Certified Action of the City of Raleigh Planning Commission

Case File / Name: SP-72-11 / 401 Oberlin Road

Staff Report

SP-72-11 401 Oberlin – Site Plan

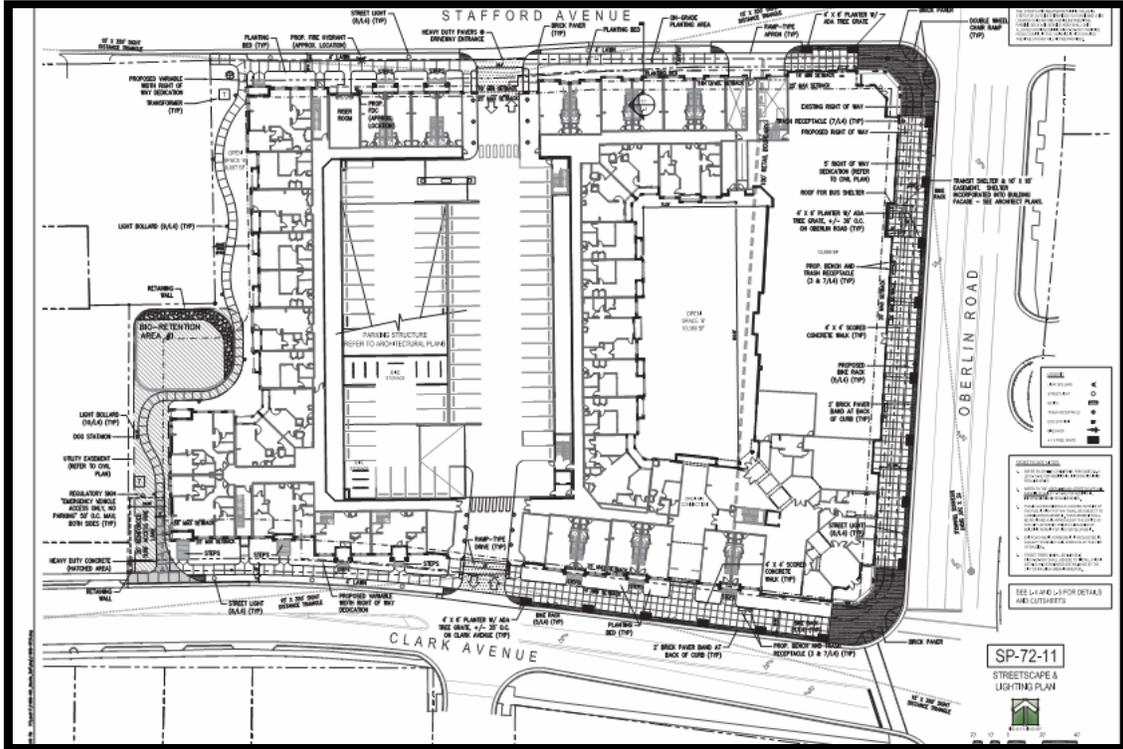
This plan conforms to all minimum setback standards. The building setbacks specified in Z-8-11 measure setbacks from the existing back of curb of the referenced streets. Front yard (Clark Avenue) = 14', rear yard (Stafford Avenue) = 14', front / rear aggregate = 14', Side yard (Oberlin Road) = 19', Side yard

Based on the property’s acreage of 2.97 acres, the base minimum amount of open space required for the tract is 15,525 square feet. The applicant’s plan for a minimum of 15,525 square feet of qualifying open space is to be provided through 20’ buffer on western property line that includes a walking trail connecting Stafford Avenue and Clark Avenue (9,087 square feet) and the pool /courtyard area (10,380 square feet). The proposed open space exceeds the minimum 12% requirement by 3,942 square feet (15% open space is provided).

TRANSIT: The following transit-oriented features of this site are incorporated into the proposed plan: The preliminary site plan shows a 10'x18' transit easement; however, zoning condition (n) requires a 10'x20'.

- (11) That a 10x20 foot transit easement located on Oberlin Road be approved by the Transit Planner in the Public Works Transportation Department, be shown on all maps for recording, and that a transit easement deed approved by the City Attorney is recorded with the local County Register of Deeds. That the recorded copy of this transit easement be provided to the Planning Department prior to building permit issuance;
